Title - Sujet Mechanical System Upgrades	
Solicitation No. - N° de l'invitation EZ899-181194/A	Amendment No. - N° modif. 005
Client Reference No. - N° de référence du client	Date 2017-10-13
GETS Reference No. - N° de référence de SEAG PW-\$PWY-020-8179	
File No. - N° de dossier PWY-7-40194 (020)	CCC No./N° CCC - FMS No./N° VME
Solicitation Closes - L'invitation prend fin at - à 02:00 PM on - le 2017-10-20	Time Zone Fuseau horaire Pacific Daylight Saving Time PDT
F.O.B. - F.A.B. Plant-Usine: <input type="checkbox"/> Destination: <input checked="" type="checkbox"/> Other-Autre: <input type="checkbox"/>	
Address Enquiries to: - Adresser toutes questions à: Ly, Ronny(PWY)	Buyer Id - Id de l'acheteur pwy020
Telephone No. - N° de téléphone (604) 318-5750 ()	FAX No. - N° de FAX (604) 775-6633
Destination - of Goods, Services, and Construction: Destination - des biens, services et construction: CSC - Kent Institution - Agassiz, BC

AMENDMENT 005

ADDENDUM #1

**MECHANICAL SYSTEM
UPGRADE FOR CELL BLOCKS**

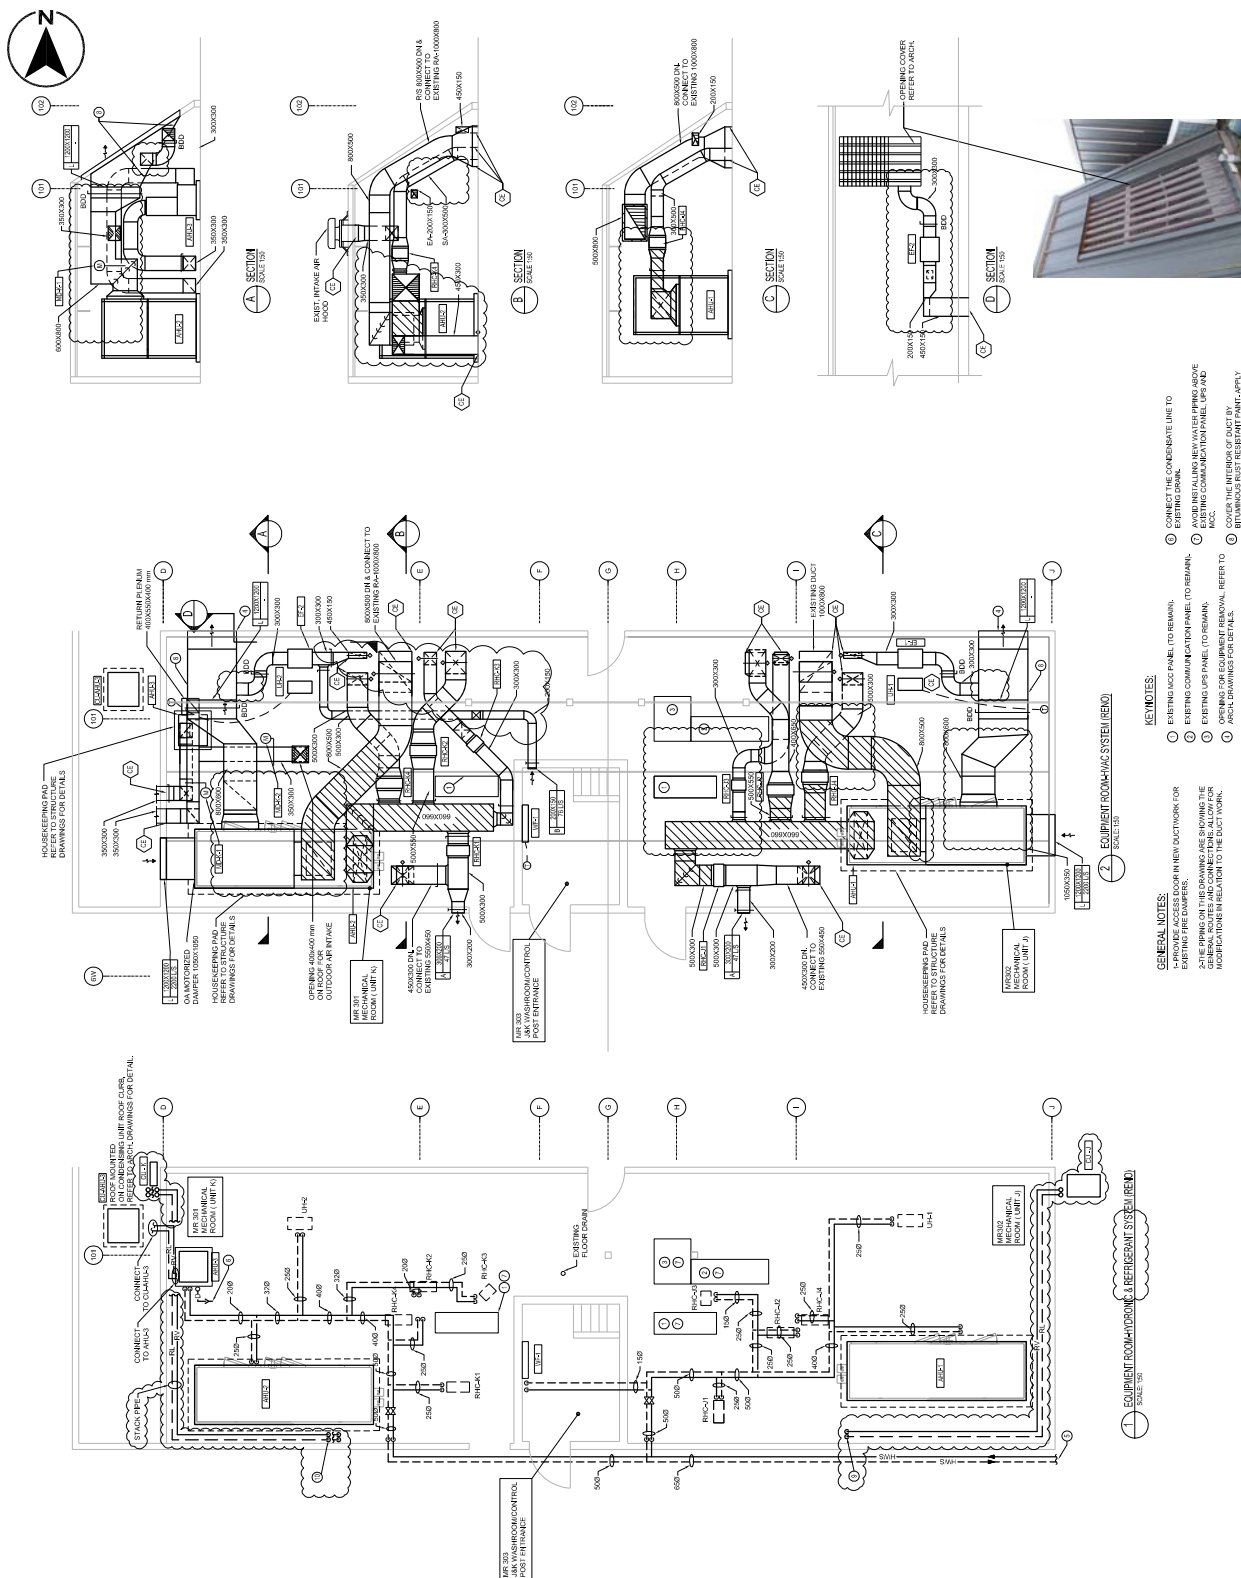
1. Add mechanical schedule for new split systems and cabinet unit heaters as shown clouded on the attached drawing.

Project No./Rev. 31 project	Sheet/Total 10 of 10	Revision No./ 1. 11. 2000 rev.
R.077723.001	M9-03	1

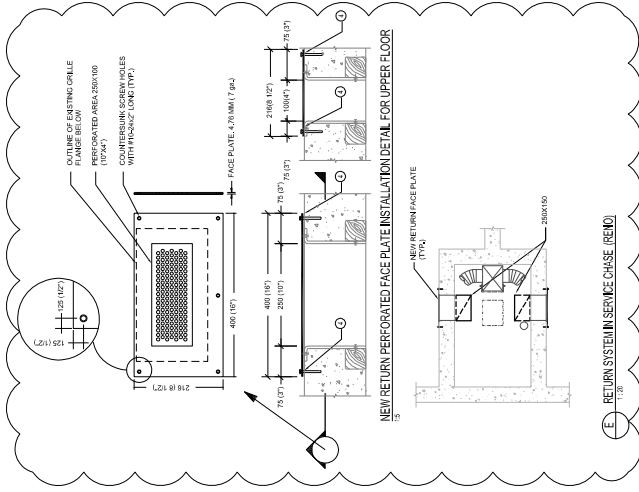
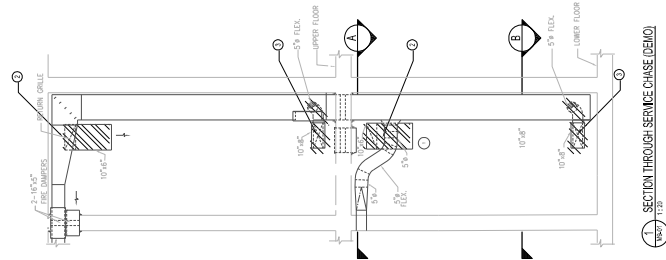
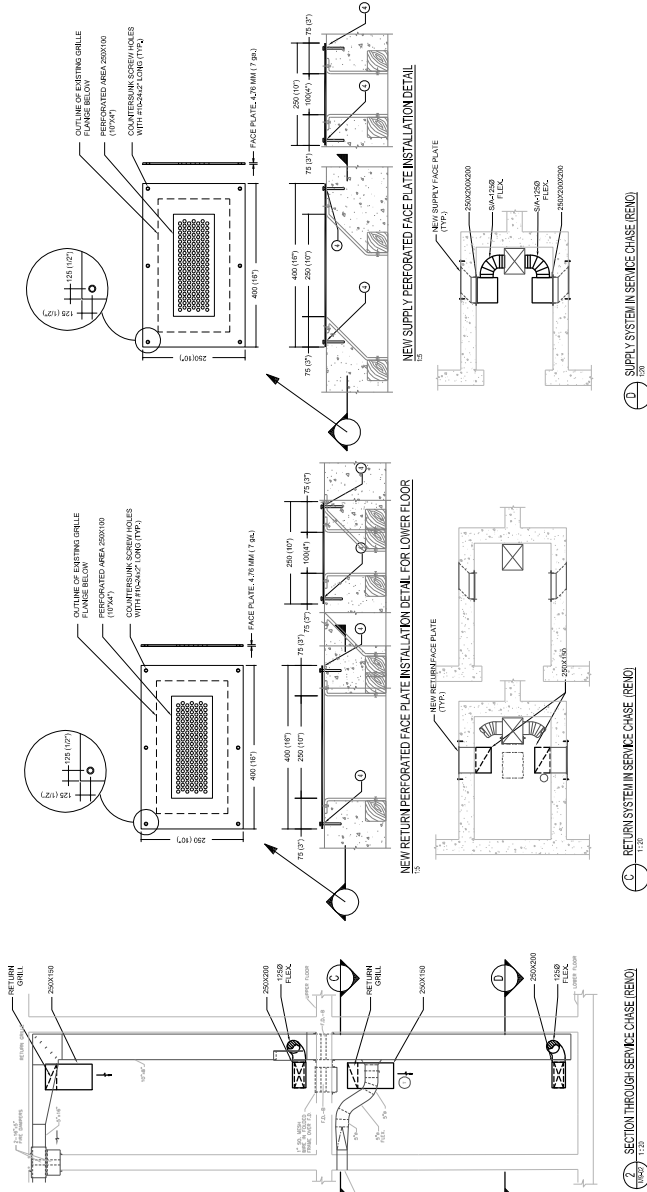
1. Add detail "E" for return air grilles at upper levels of Living Units A to H as shown clouded on the attached drawing.

- ① DEMOLISH THE BLADES FROM EXISTING RETURN AND SUPPLY GRILLE, SEE PHOTO-142.
- ② DEMOLISH RETURN DUCT.
- ③ DEMOLISH SUPPLY DUCT.
- ④ APPLY PICK-PROOF AND TAMPER-PROOF SECURITY SEALANT WITH SHORE HARDNESS OF NOT LESS THAN 70 ALL AROUND AND BELOW THE GRILLES FLANGE IN CONTACT WITH CONCRETE.
